ERI Huron Main Street
ODOT PID No. 118507
Federal Agreement No. 43204
City of Huron

ADDENDUM #02

DRIVE DETAILS

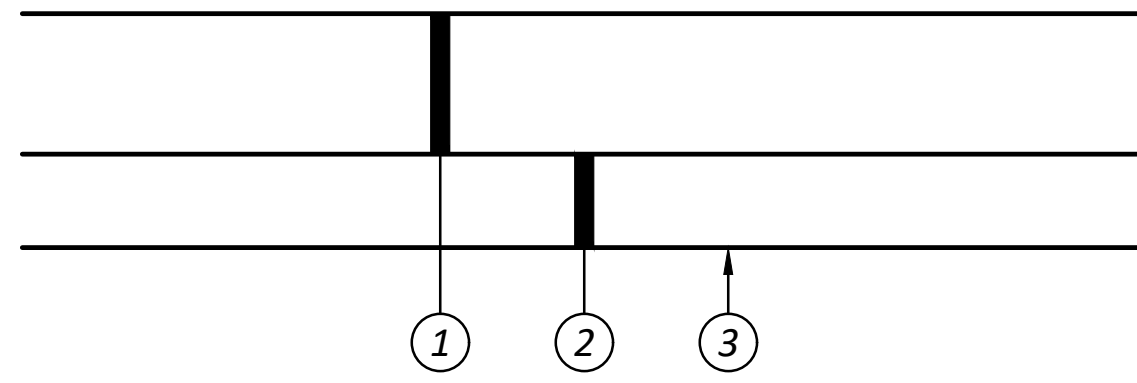
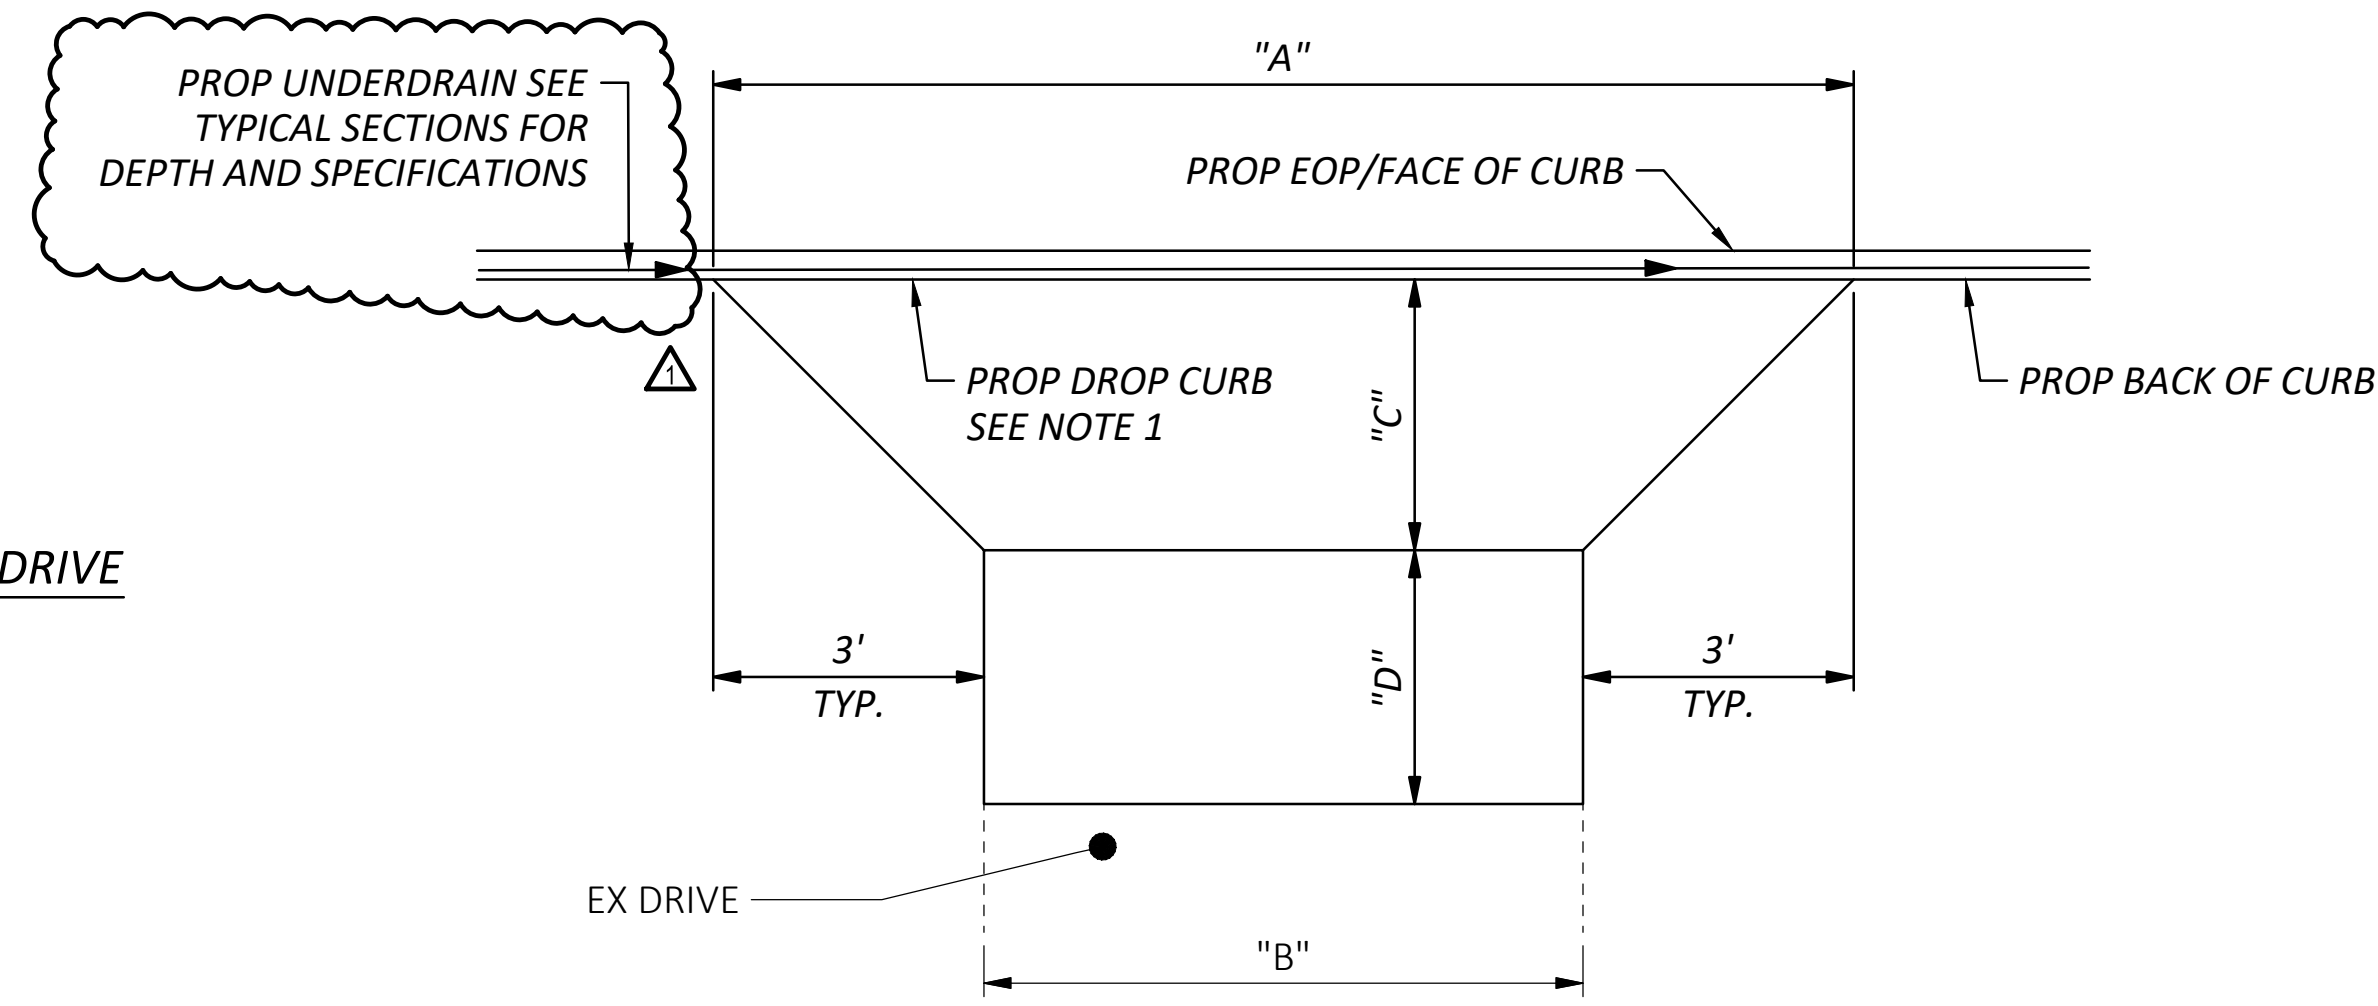
1. Question: Page 9 has a note for the Non Reinforced Concrete Pavement Misc items, it states there are to be dowels at contraction joints. Do you really want dowels in drives or is this note intended for another item. It also refers to BP 2.3 which I do not believe applies at all.
 - a. **Engineer Response: This note is intended for the pavement repair and replacement. The driveways are not needed to be doweled as per BP-2.2. BP2.3 has been revised to BP-2.5**

1. ALL COSTS FOR ITEM 452 - NON-REINFORCED CONCRETE PAVEMENT, MISC.: CONCRETE DRIVE SHALL BE INCLUDED IN THE UNIT COST BID FOR ITEMS 1-3 (INCLUDING SAWCUT, REMOVAL OF EXISTING PAVEMENT, JOINT SEALING, AND ALL ITEMS SHOWN). ALL REPLACEMENTS TO BE A MINIMUM OF 2' WIDE OR TO THE NEAREST JOINT.
2. USE MICROFIBER AT A MIX DOSAGE RATE OF 3 LB/CY.

CURB NOTES

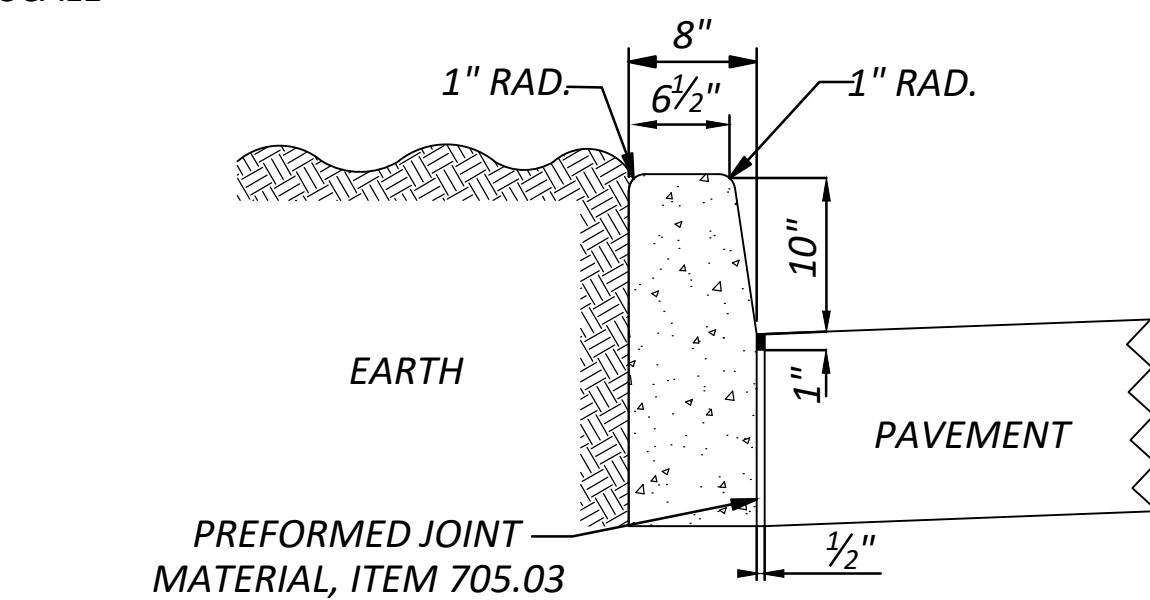
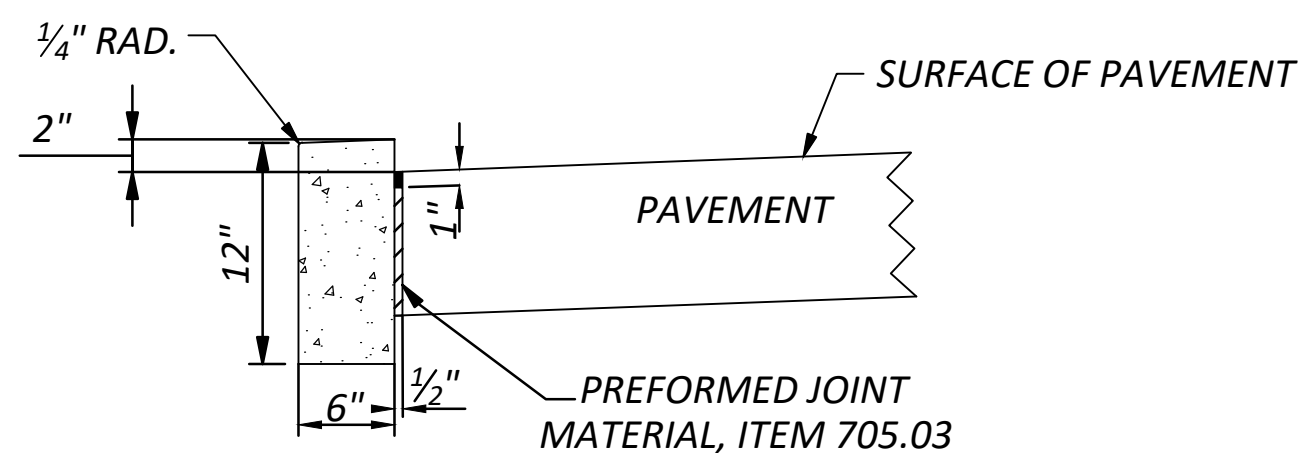
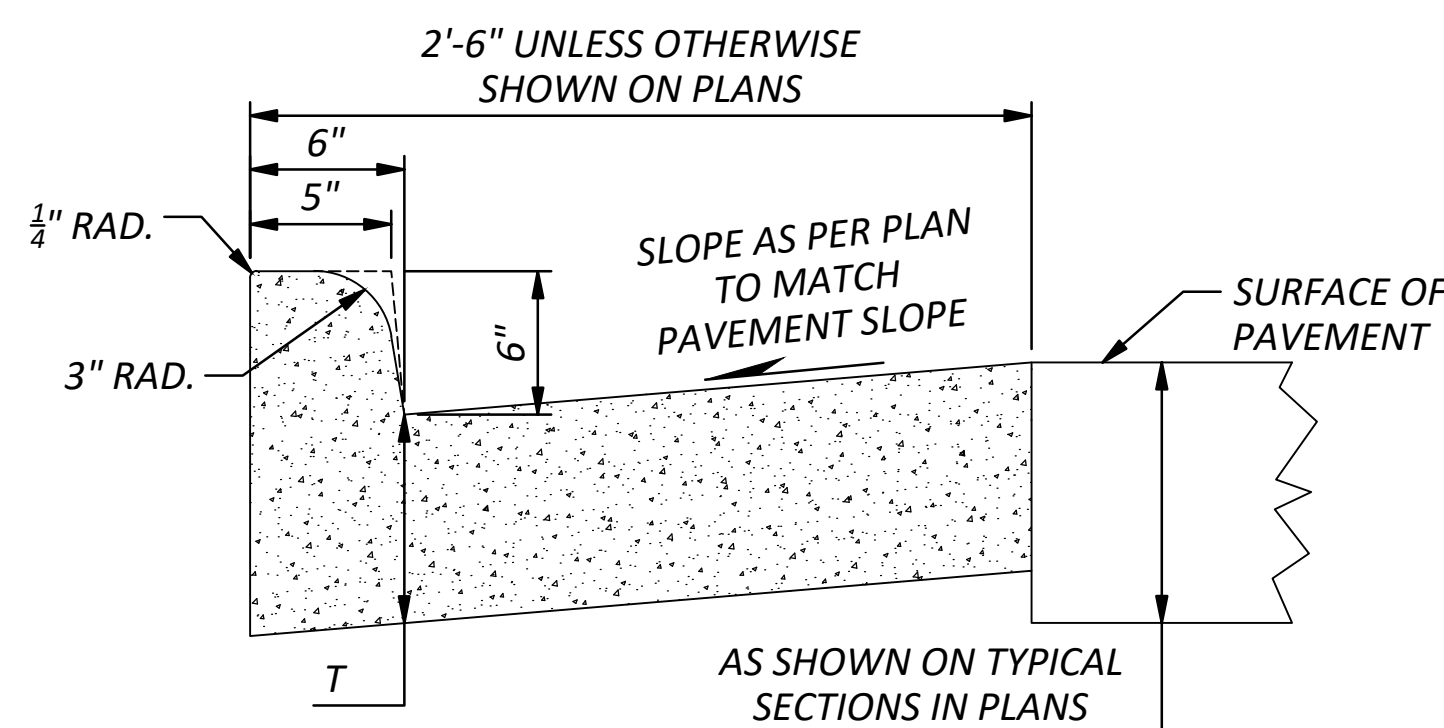
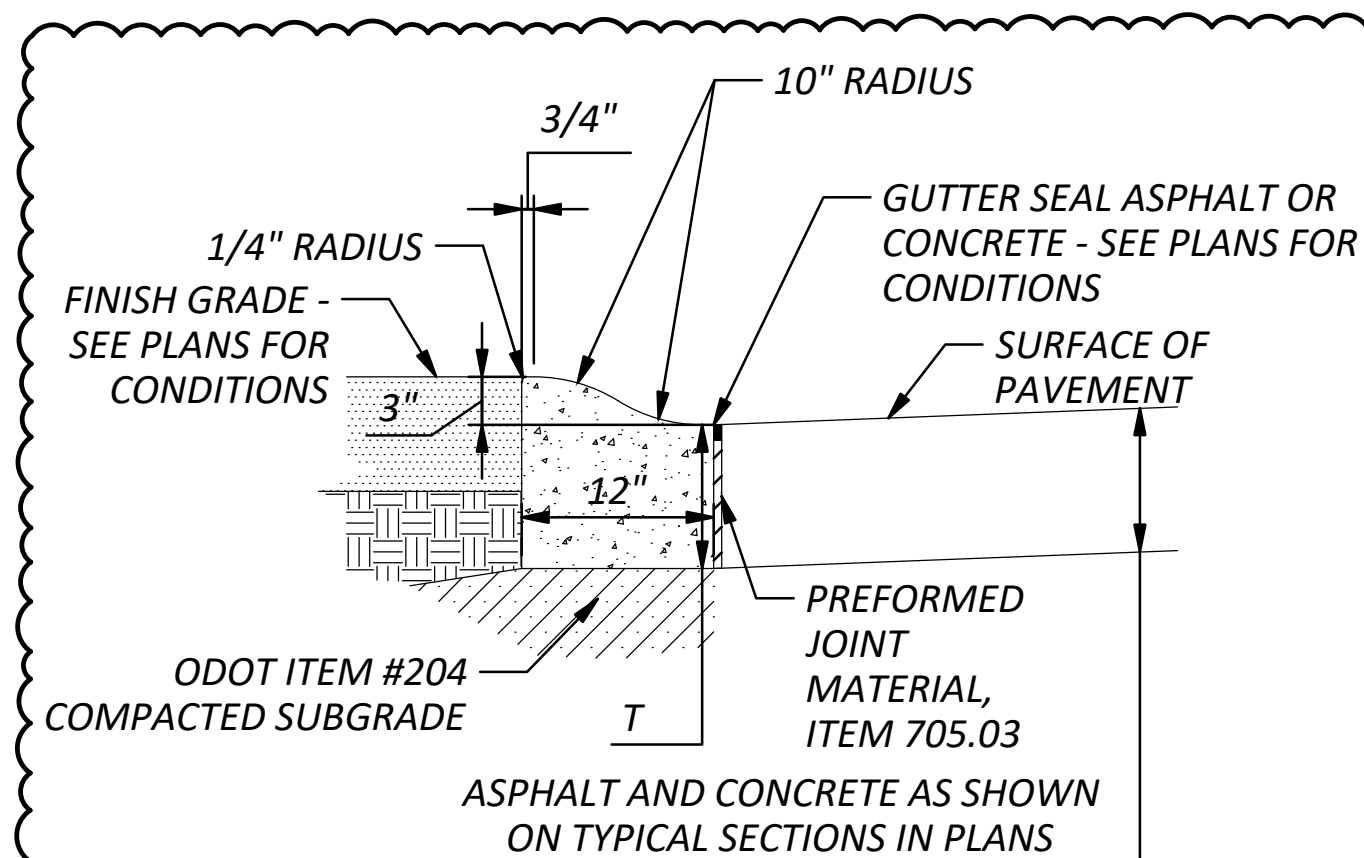
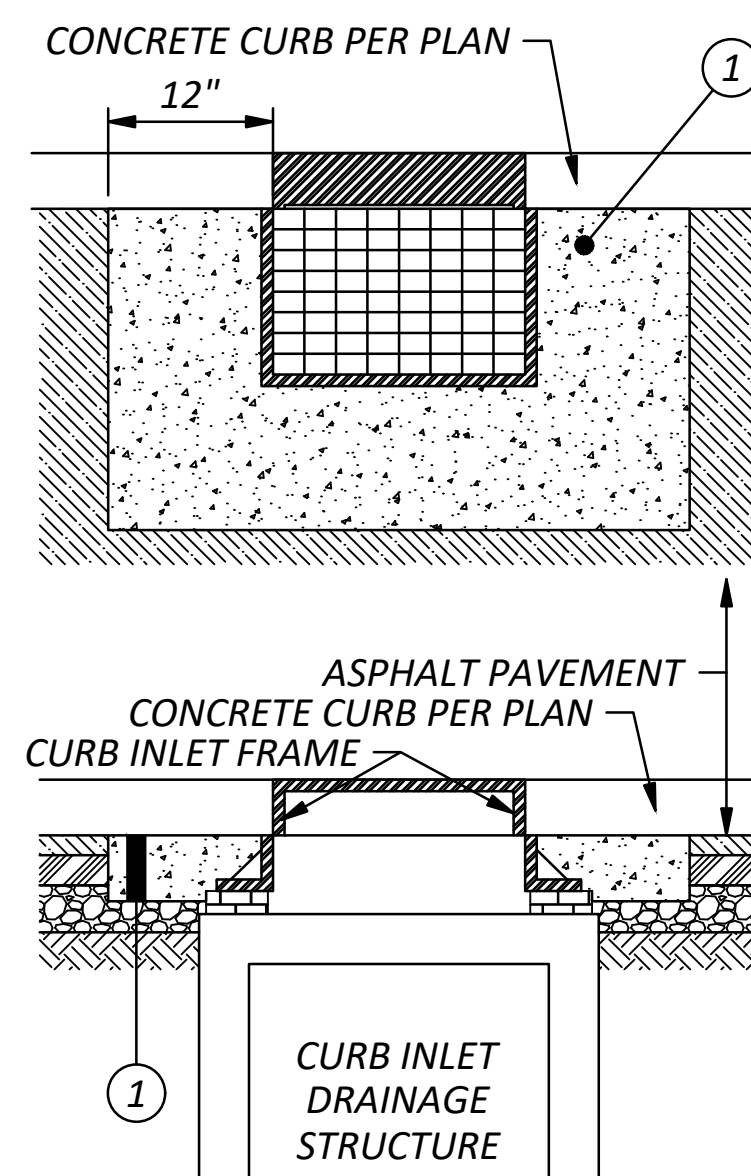
2. Question: Page 40 calls for all curb to have expansion at 20' o/c and be poured integral. Do you really want expansion 20' o/c? A good deal of the curb will have to be poured separately as well.
 - a. **Engineer Response: Curb expansion shall match the pavement expansion joints, or as directed in the field. Curb expansion can be spaced up to 40' on center.**

1. PROVIDE 1/2" EXP. JOINT WHEN ADJACENT TO CONCRETE PAVEMENT, UNLESS POURED INTEGRALLY WITH PAVEMENT.
2. PLACE CONTROL JOINTS 6' O.C. MAX., OR AS SHOWN ON PLANS.
3. PLACE 1/2" EXPANSION JOINTS RECESSED 1/2" FROM SURFACE FOR JOINT SEALER PER ITEM 705.04, AS DIRECTED IN THE FIELD.
4. CONCRETE MIXTURE SHALL BE SAME AS CONCRETE WALK.
5. CONTRACTOR SHALL INCLUDE ALL LABOR, MATERIALS, AND EQUIPMENT NECESSARY TO COMPLETE THIS ITEM PER ODOT CMS 609, AND AS SHOWN ON THIS DETAIL.

TYPICAL CONCRETE WALK & CURB RAMP DETAIL

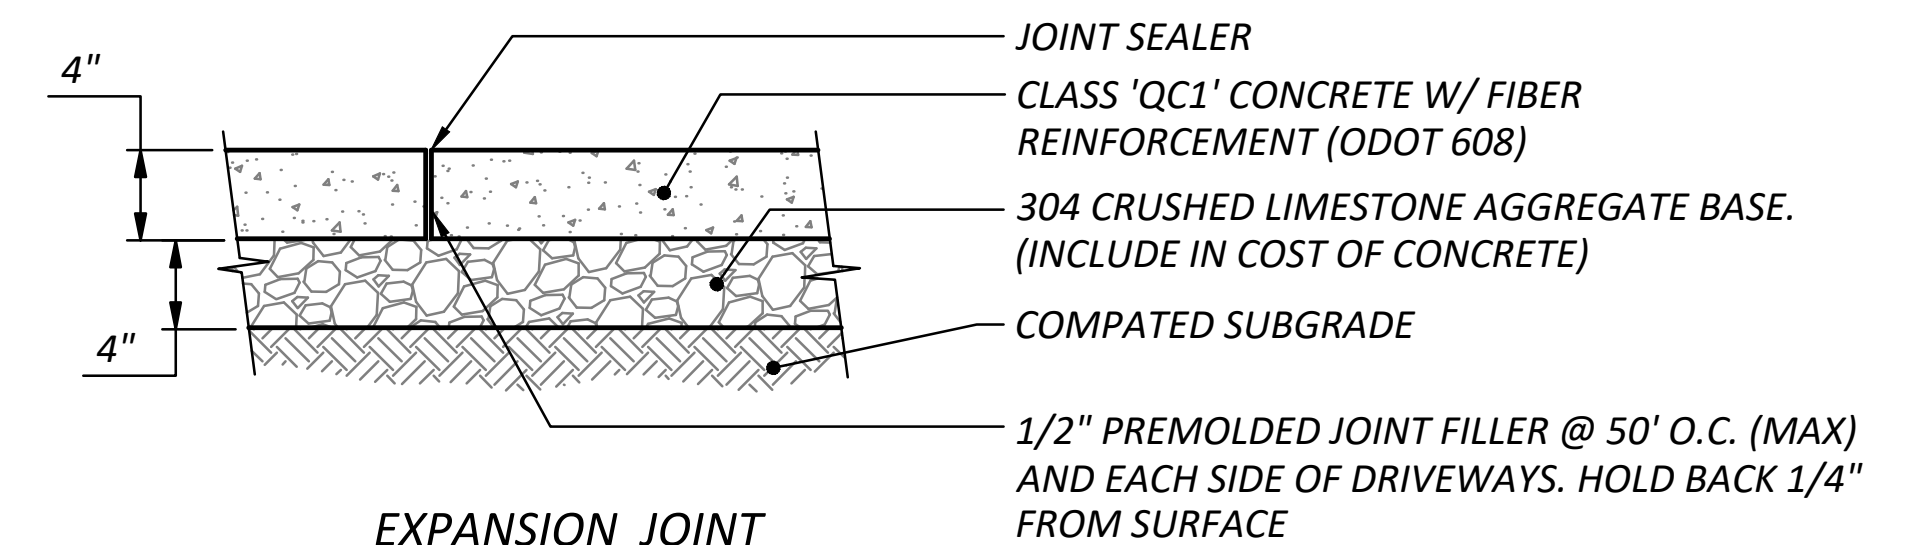
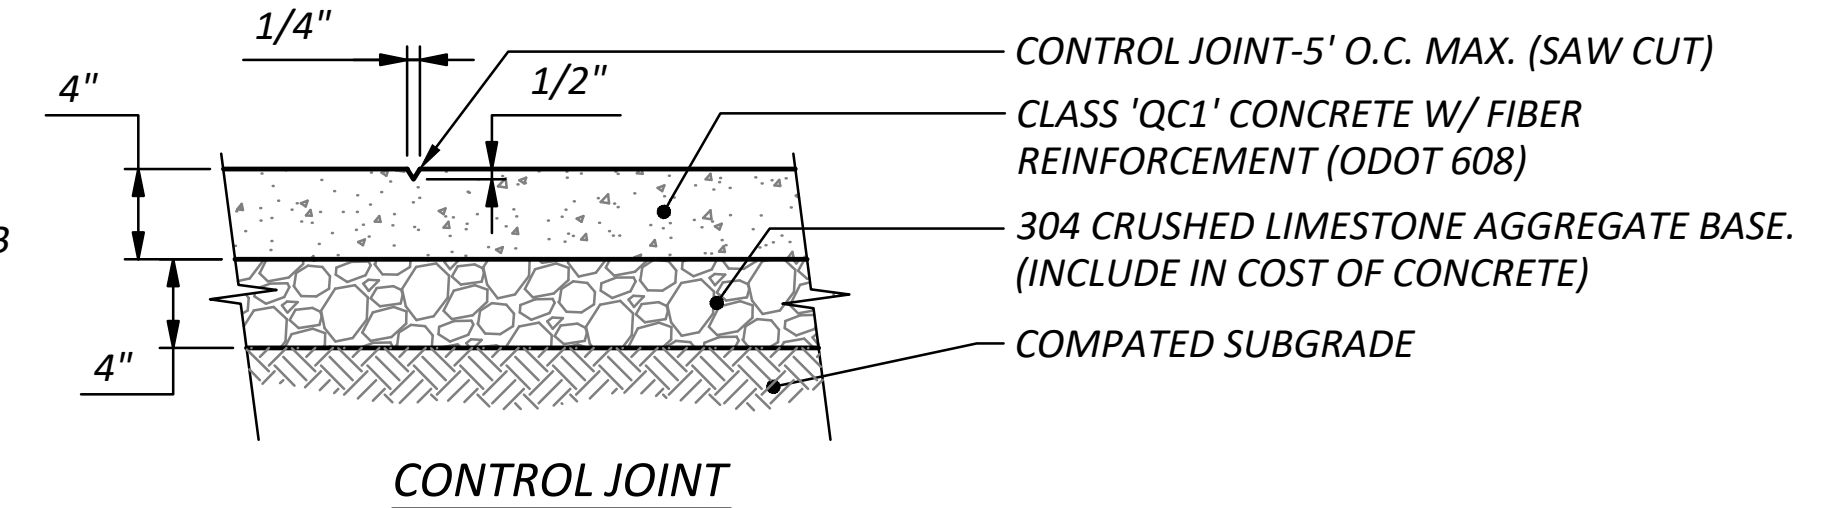
4. Question: Page 9 calls for Polymer Detectable Warning Mats, page 61 calls for cast iron. Which is correct?
 - a. **Engineer Response: Detectable warning mats shall be cast iron with black asphaltic coating (dipped). Drawings have been revised for clarification.**

DETECTABLE WARNING DEVICES SHALL BE LIMITED TO CAST IRON WITH BLACK ASPHALTIC COATING (DIPPED), COLOR: BLACK.
